PCN-20200818 KK0807-02 to KK0807-02A Hardware Revision Change

Company	Trenz Electronic GmbH
PCN Number	PCN-20200818
Title	KK0807-02 to KK0807-02A Hardware Revision Change
Subject	Hardware Revision Change
Issue Date	2020-10-02

#1 Added four M3 mountig holes.

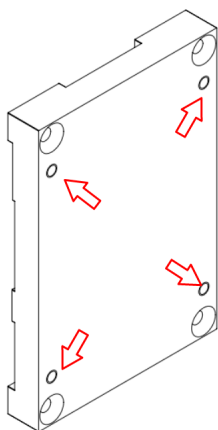
Type: Hardware change

Reason: Request for screwed mounting of cooler on heatspreader.

Impact: The heatspreader is compatible with cooler KK0001-01.

Models with 4 additional threads are revision 02A.
